DEVIATION REQUEST AND DECISION FORM

Project Name : Mayberry Phase 1
 Schedule No.(s) : PUDSP219, including SF1825 (Filing 1), VR2113 (Filing 1A), VR2322 (Filing 1B), SF2219 (Filing 3)
 Legal Description : NE1/4 of Sect 15 & N1/2 of Sect 14, Township 14 S, Range 63 W of 6th P.M., El Paso County, Colorado

A deviation from the standards of or in Section **2.4.1.E-1** of the Engineering Criteria Manual (ECM) is requested.

EXHIBIT 'B'
Example ECM Compliant Driveway
Block Layout

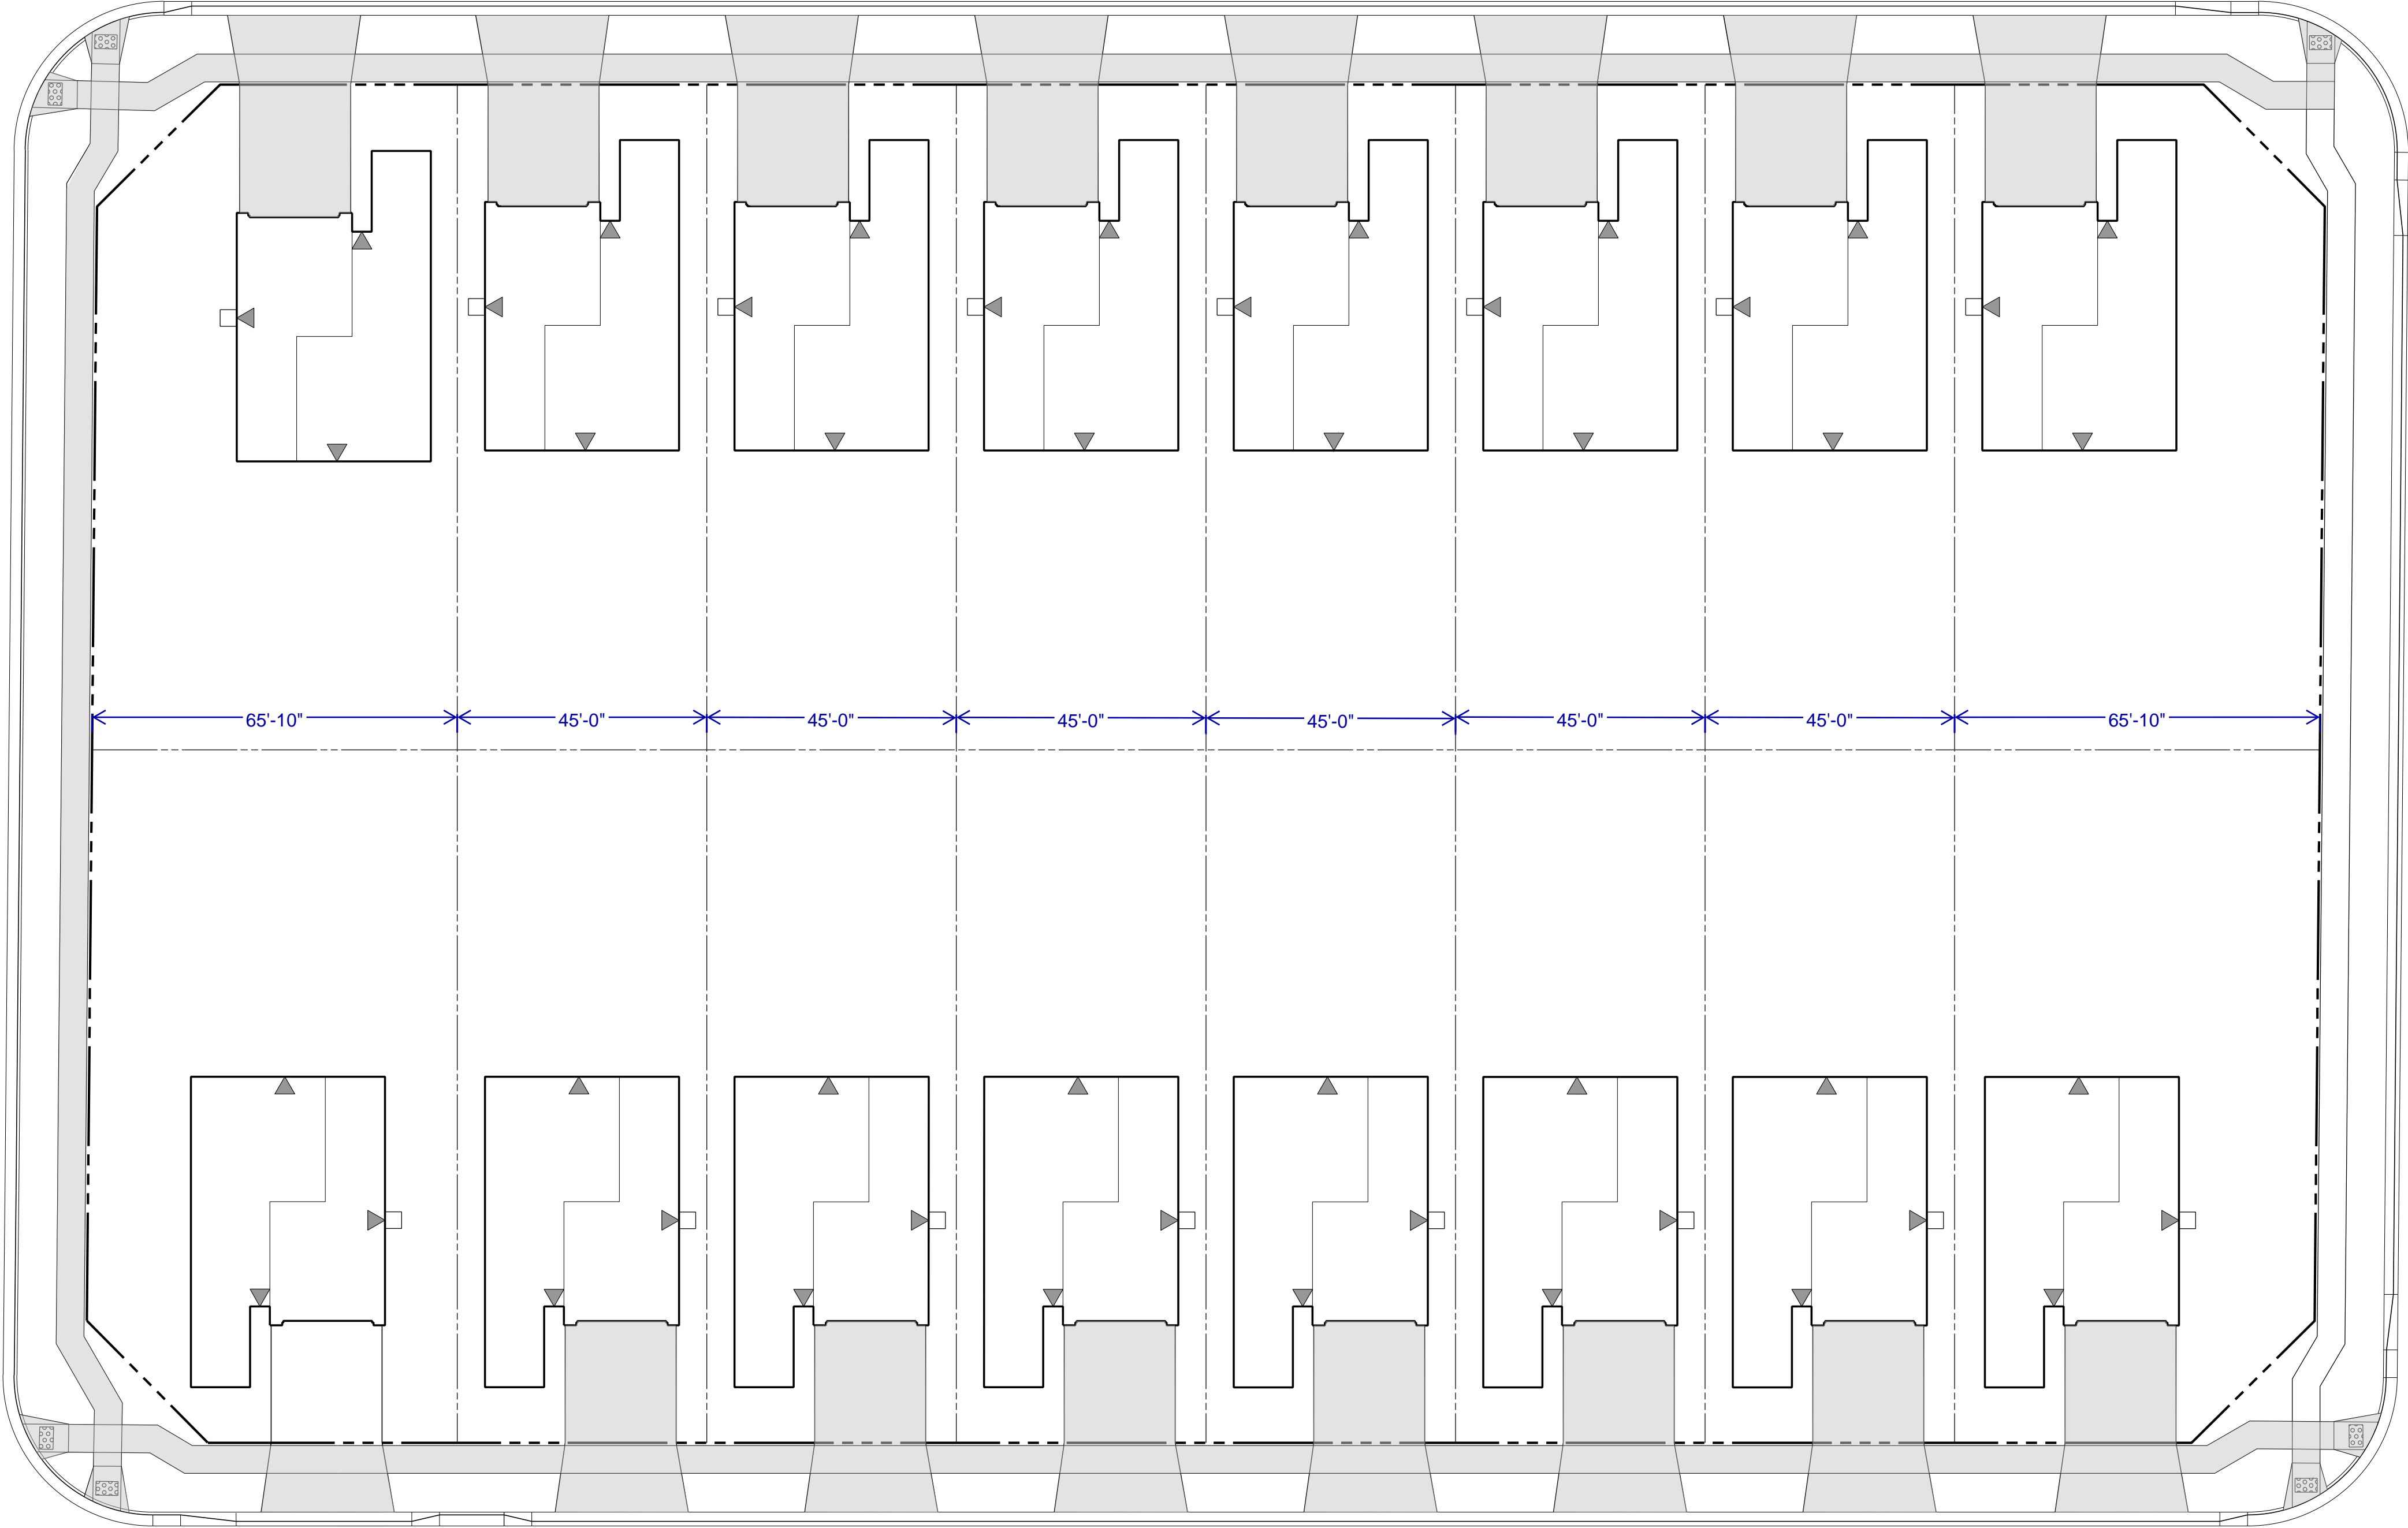
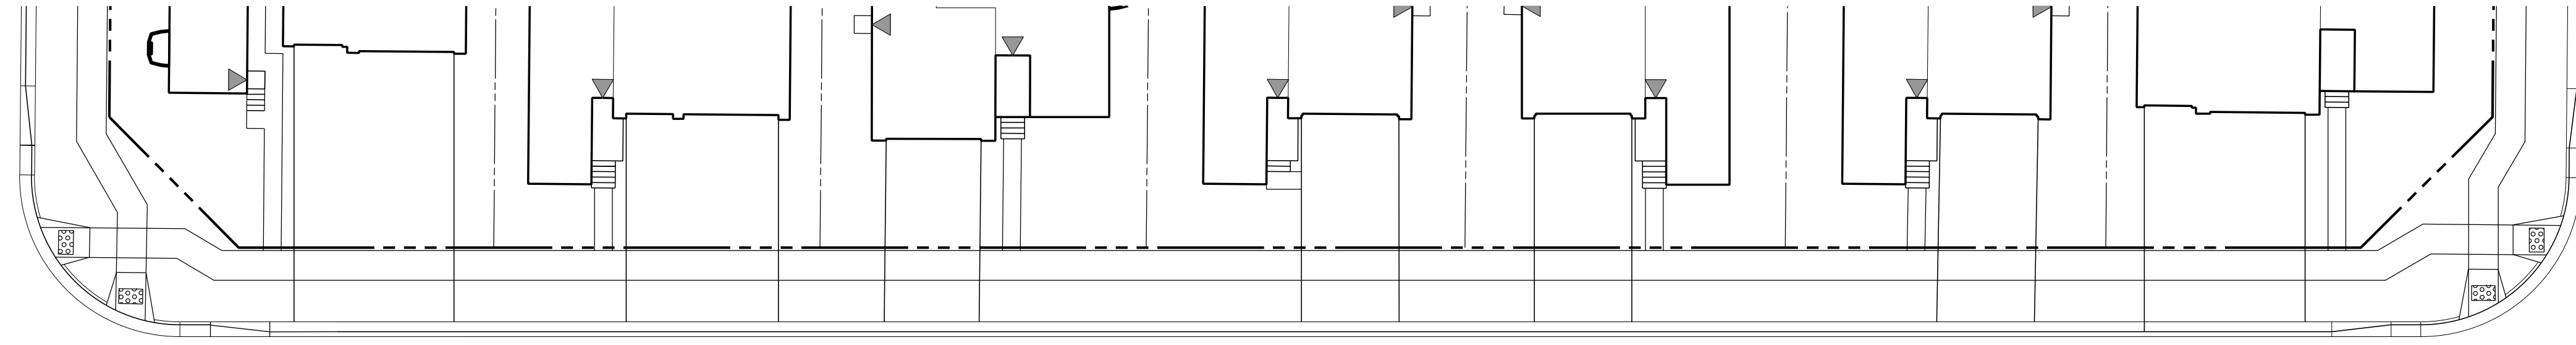
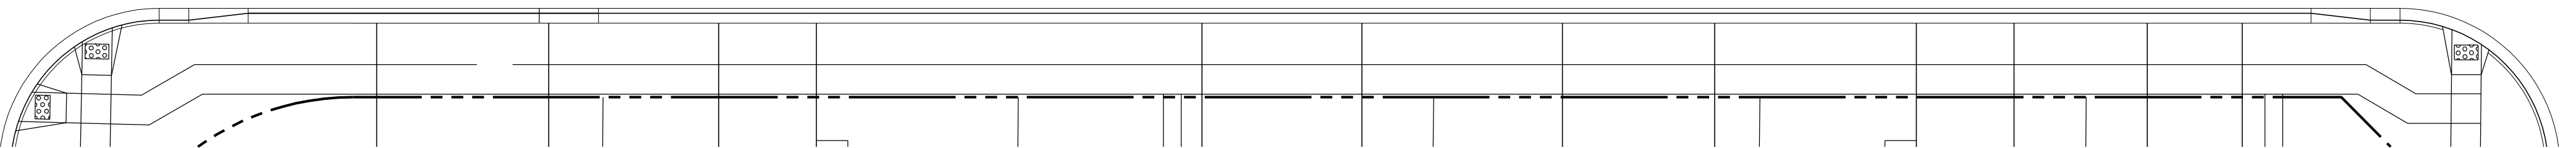
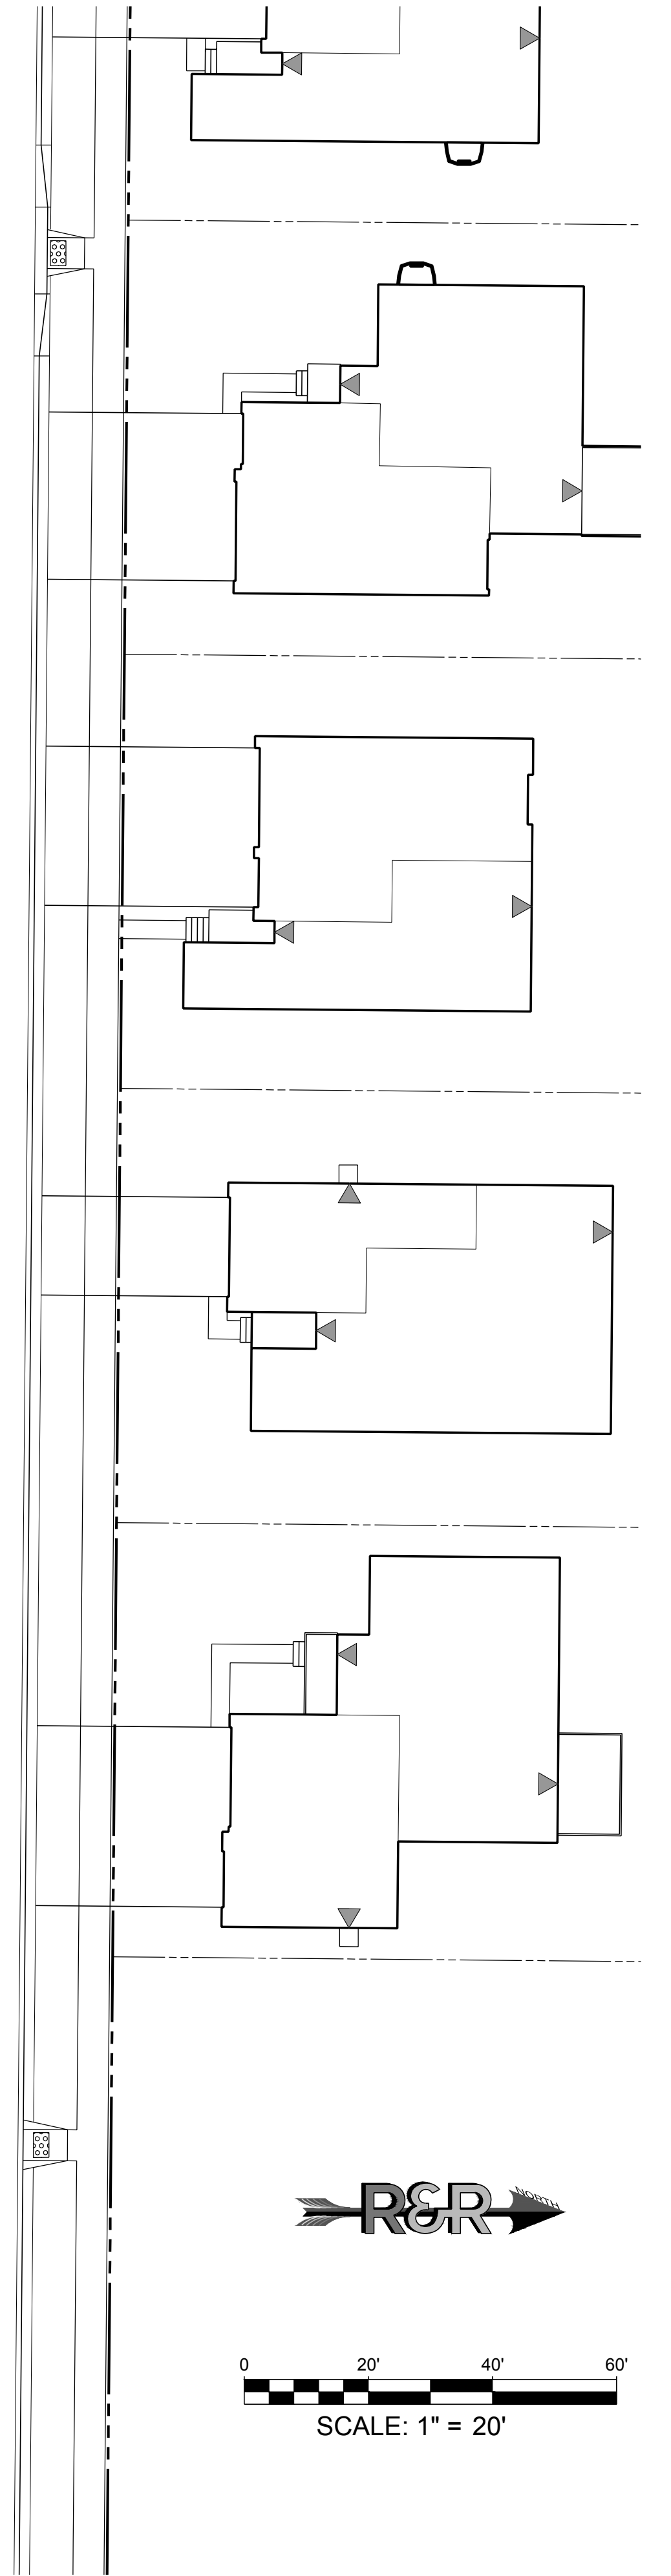
The Exhibit 'B' provides a schematic illustration of lots 45' in width with ECM maximum 24' wide driveways, all evenly spaced, while Exhibit 'C' illustrates a sample block layout of actual Mayberry homes designed with driveway layouts conforming to the criteria requested through this deviation request. These exhibits demonstrate that this deviation meets the design intent and purpose of the ECM standards.
